TITLE: CHANGE OF ZONE NO. 05061, Southwest Village Planned Unit Development, from AG Agricultural District and AGR Agricultural Residential District to B-2 Planned Neighborhood Business District PUD, requested by Kent Seacrest on behalf of Ridge Development Company and Southview, Inc., on property generally located at South Folsom Street and West Denton Road.

LINCOLN/LANCASTER COUNTY PLANNING STAFF REPORT

PROJECT #: Annexation #05014
Change of Zone #05061 - AG and AGR to B-2 PUD
Change of Zone #05062 - AG and AGR to R-3 and R-4

UNIT FLOOR PLANS

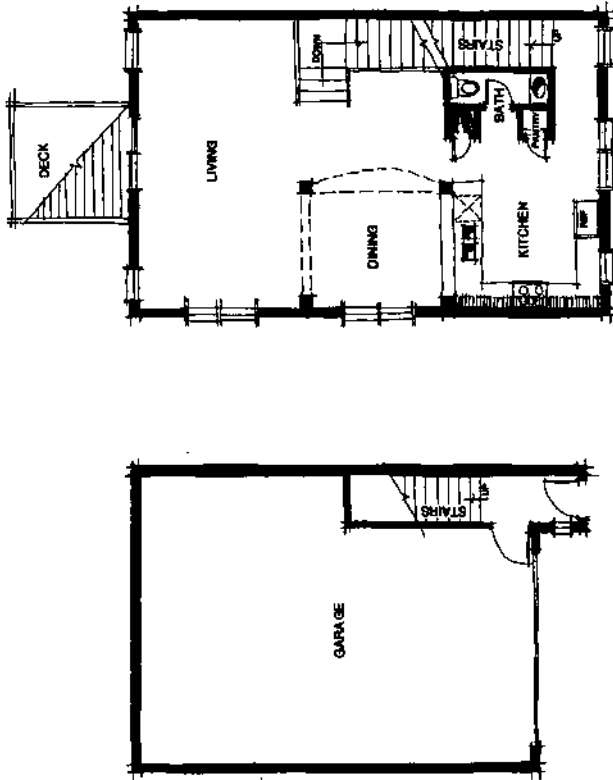
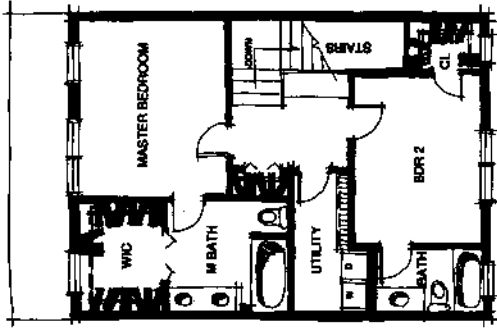
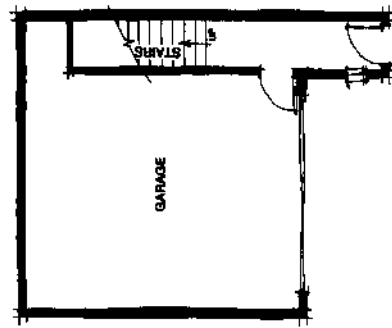
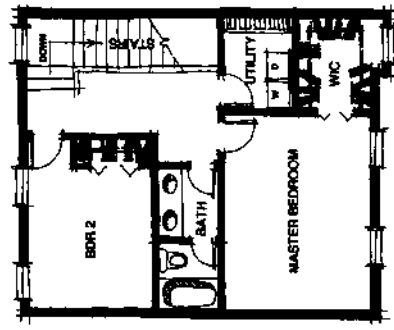
- 1.1.14 The surveyor and engineer certificates must be signed.
- 1.1.15 Revise the typical lot detail for the townhouses on Sheet 3 of 21 to show a minimum dimension of 22' from the back of sidewalk to the garage. **(**Per Planning Commission, at the request of the applicant, 11/23/05**)**
